IEEE P802.15 Wireless Personal Area Networks

Project	IEEE P802.15 Working Group for Wireless Personal Area Networks (WPANs)	
Title	TG3 D10 running comment resolutions	
Date Submitted	[8 July, 2002]	
Source	[James P. K. Gilb] [Apparent Technologies] [9921 Carmel Mountain Rd. #247, San Diego, CA 92129]	Voice: [858-538-3903] Fax: [858-538-3903] E-mail: [gilb@ieee.org]
Re:	[]	
Abstract	[This document is a record of comment resolutions for LB17.]	
Purpose	[To provide a record of the comment resolution for LB17.]	
Notice	This document has been prepared to assist the IEEE P802.15. It is offered as a basis for discussion and is not binding on the contributing individual(s) or organization(s). The material in this document is subject to change in form and content after further study. The contributor(s) reserve(s) the right to add, amend or withdraw material contained herein.	
Release	The contributor acknowledges and accepts that this contribution becomes the property of IEEE and may be made publicly available by P802.15.

1. Comment resolution in Schaumburg

Figure 6—Source DEV-2 Terminating its stream

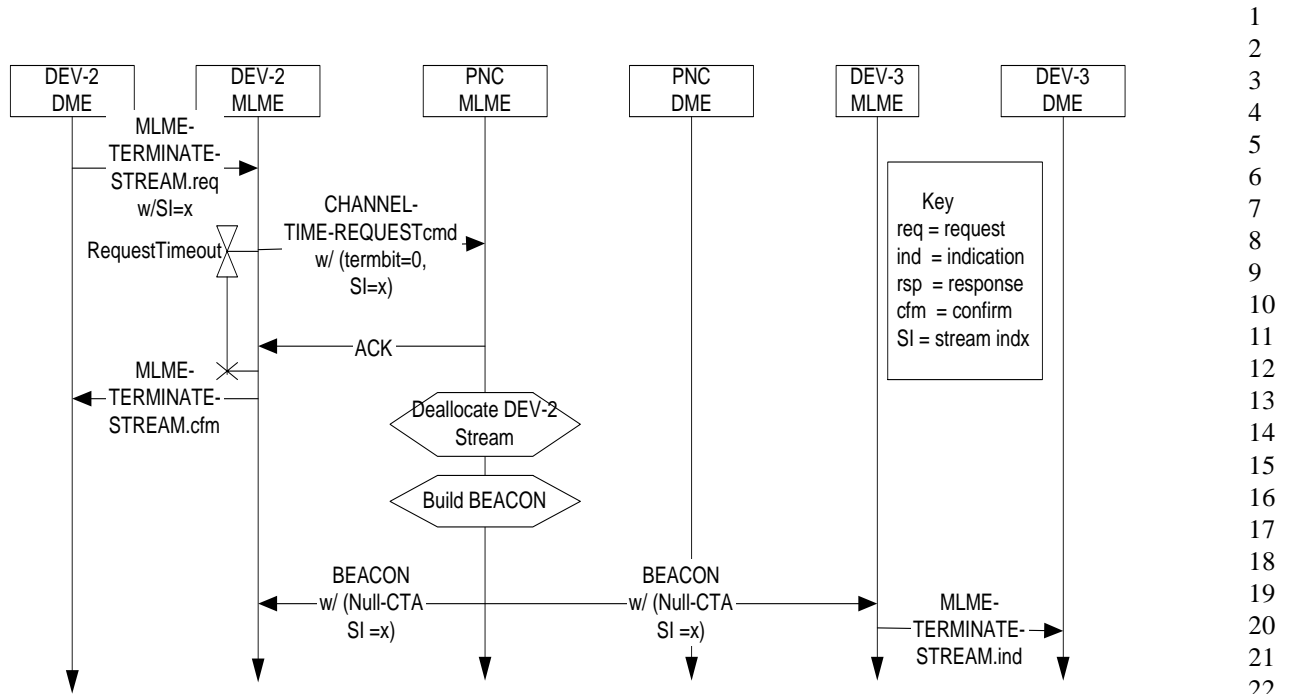
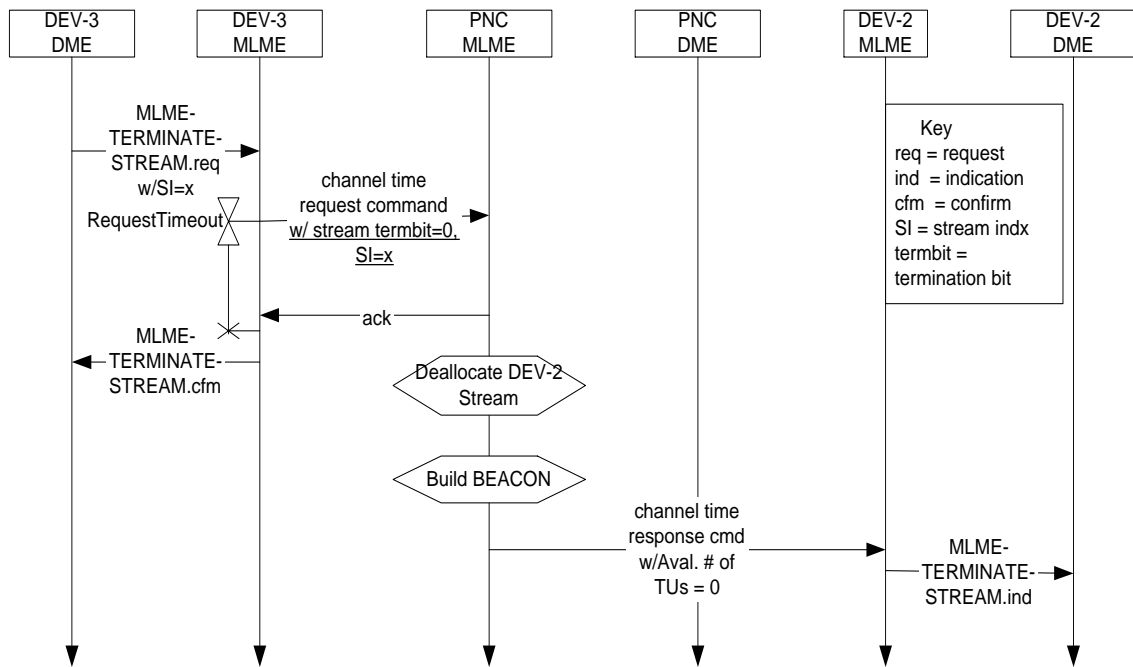
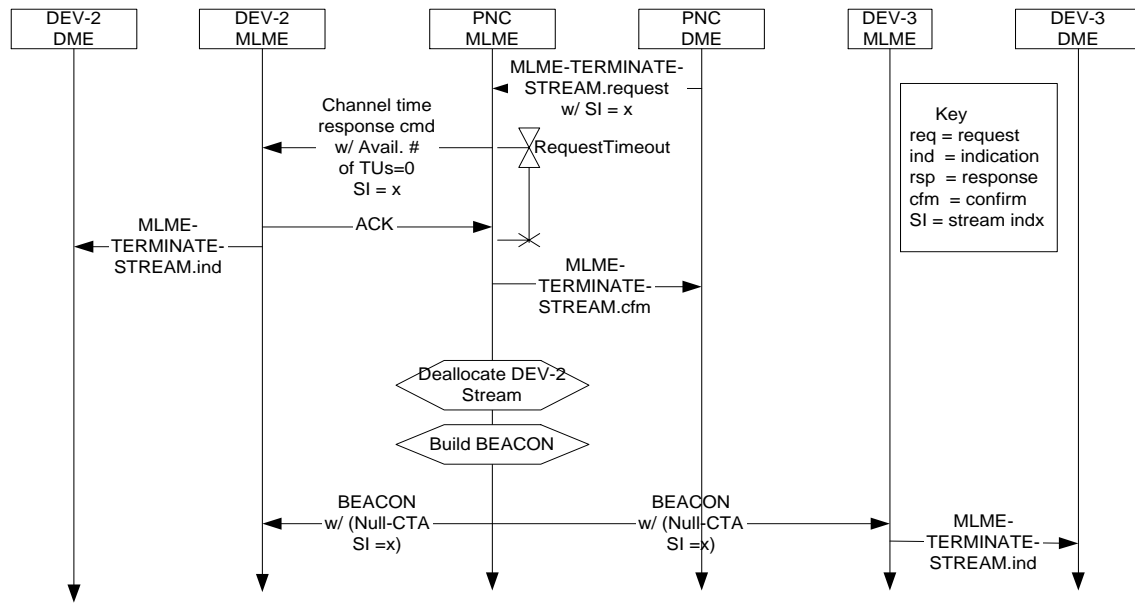
907 (Bain,TR) Grammatical errors and reference to figure 118 is incorrect and does not pertain to text in this section. Consequently, change the paragraph to the following: "In the case where the PNC wishes to terminate the stream, it shall notify the originating DEV and the target DEV via the next periodic beacon that the CTAs assigned to the indicated stream index are set to a null CTA value for aMinBeaconInfoRepeat duration." **Suggest reject** pending acceptance of CID 364

340 (Heberling, TR) - The rules for association and authentication with PNC are inconsistent. < add text> In a piconet operating in security mode 0 or 1, an association shall also imply authentication. No authentication frame exchange shall be done with PNC in these modes. Suggest accept in principle, "A DEV will become a 'member of the piconet' or have 'membership in the piconet' when it is associated for mode 0 or completes authentication for mode 1, 2 or 3. Text will be added to specify this and the draft modified to use 'membership' instead of 'associated, and if required authenticated'. Note that the authentication process for mode 1 will be resolved as a part of another comment. If a null security suite is used, then the authentication process will be required. Otherwise, it will have the status of mode 0, i.e. that association is equivalent to authentication."

Resolution is to reject, "Figure 118 has been removed, a new termination procedure in 02/273r13 describes with correct MSCs the procedure."

The PNC, upon receiving a channel time request command from a DEV requesting stream termination, shall respond with an ACK. In the case where the stream originating DEV is requesting a stream termination, the PNC shall then notify the target DEV of the termination via a null CTA in the beacon for {xref aMinBeaconInfoRepeat} duration. For CTAs that were not allocated every beacon, e.g. subrate slots, the null CTAs shall be placed starting in the beacon where the next CTA would have occurred and in the following {xref aMinBeaconInfoRepeat}-1 beacons. A null CTA has the stream index, SrcID and DestID with zero values for the slot location and slot duration, {xref 7.4.8}. {xref Figure 6} illustrates the MSC for termination of a stream by a source DEV. In the case where the target DEV is requesting a stream termination, the PNC shall then notify the stream originating DEV of the termination via a channel time response command. {xref Figure 7} illustrates the MSC for termination of a stream by a target DEV.

In the case where the PNC decides to terminate a stream originating DEV's stream, the PNC shall notify the source DEV via a channel time response command and the target DEV via a null CTA in the beacon for aMinBeaconInfoRepeat duration. For CTAs that were not allocated every beacon, e.g. subrate slots, the null CTAs shall be placed starting in the beacon where the next CTA would have occurred and in the following {xref aMinBeaconInfoRepeat}-1 beacons. {xref Figure 8} illustrates the termination of a source DEV's stream by the PNC.

Figure 11—MSC for the initiating of a neighbor piconet.

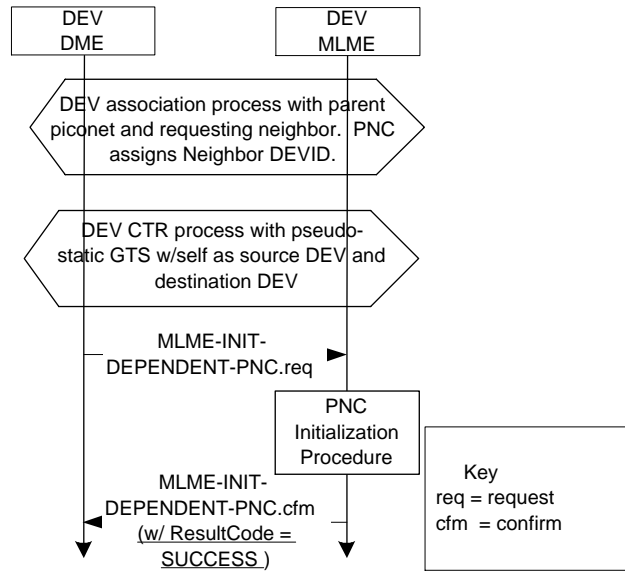
179 (Heberling, TR) - Figure 98 should be replaced with a proper MSC of the required protocol needed to establish a neighbor piconet. Replace figure 98 with a proper MSC. **Suggest accept** - An MSC for neighbor piconet initialization is included below. It needs twiddling to get the vertical lines to not show in the hex pro-

cess blocks. Also, although consistent with other similar diagrams, this MSC seems to need the first beacon of the neighbor PNC shown.

The MSC for the initiation of the neighbor piconet is illustrated in Figure 11.

Accept in principle, “Accept suggested resolution but add a line at the bottom that shows the first beacon being sent. Also add after the sentence that says ‘The MSC for the initiation a neighbor piconet is illustrated in Figure 11.’ the following sentence, ‘The association and channel time request processes are defined in xref and xref, respectively.’”

Figure 12—MSC for the creating a child piconet.

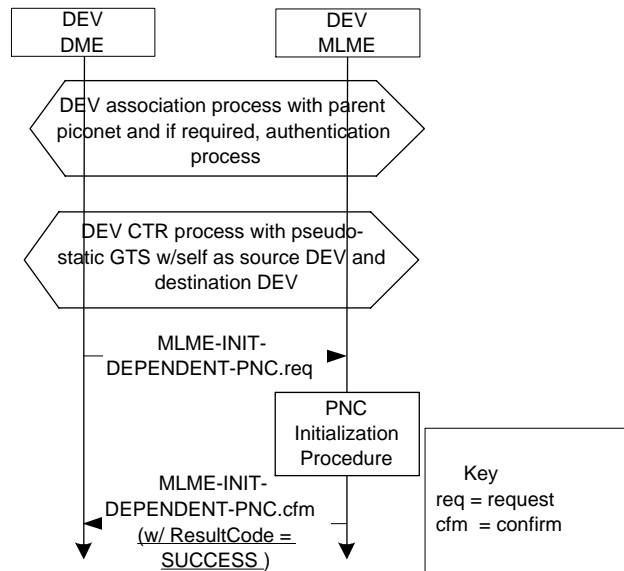
177 (Heberling, TR) - Figure 96 should be replaced with a proper MSC of the required protocol needed to establish a child piconet. Replace figure 96 with a proper MSC. **Suggest accept** 'An MSC for child piconet initialization is included below. It needs twiddling to get the vertical lines to not show in the hex process blocks. Also, although consistent with other similar diagrams, this MSC seems to need the first beacon of the child PNC shown.

The MSC for creating a child piconet is illustrated in Figure 12.

Accept suggested resolution but add a line at the bottom that shows the first beacon being sent. Also add after the sentence that says 'The MSC for creating a child piconet is illustrated in Figure 12.' the following sentence, 'The association and channel time request processes are defined in xref and xref, respectively.'

Figure 13—MSC for a approved asynchronous channel time request

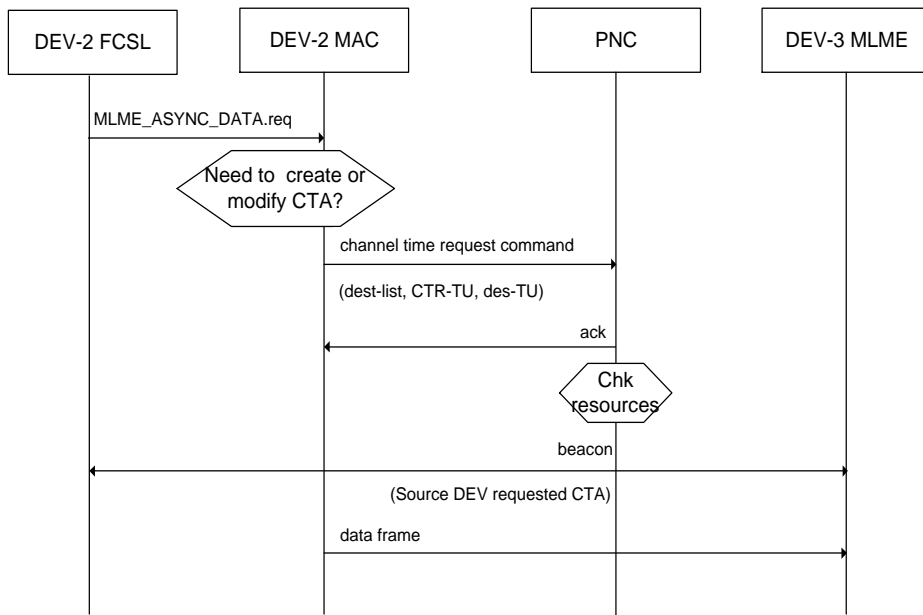
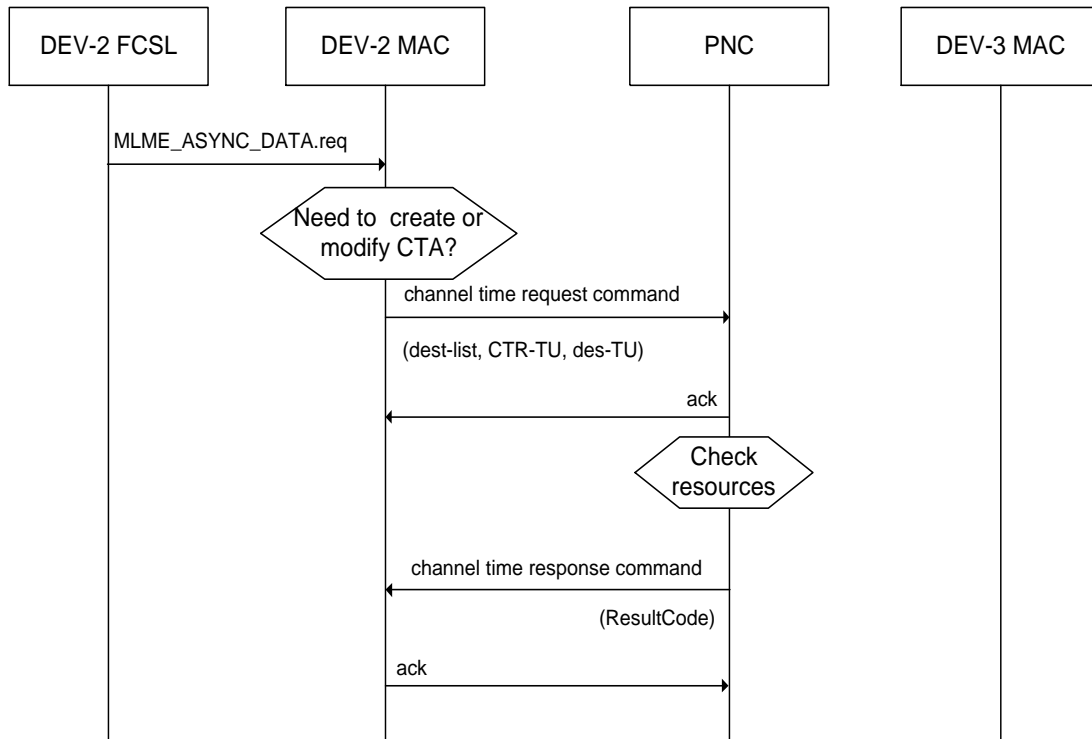
327 (Heberling, TR) Figure 119 is a flawed MSC of the Asynchronous channel time reservation process and data frame exchange. Consequently, delete the current MSC from this section of clause 8.5.2.1 and replace it with 02r0P802-15_TG3-Asynch-channel-time-allocation.eps. **Suggest accept.**

<Page 182, Figure 119> – MSC for reserving asynchronous data channel time. Discussed earlier, new MSC is below (needs work to match the other MSCs in the clause.):
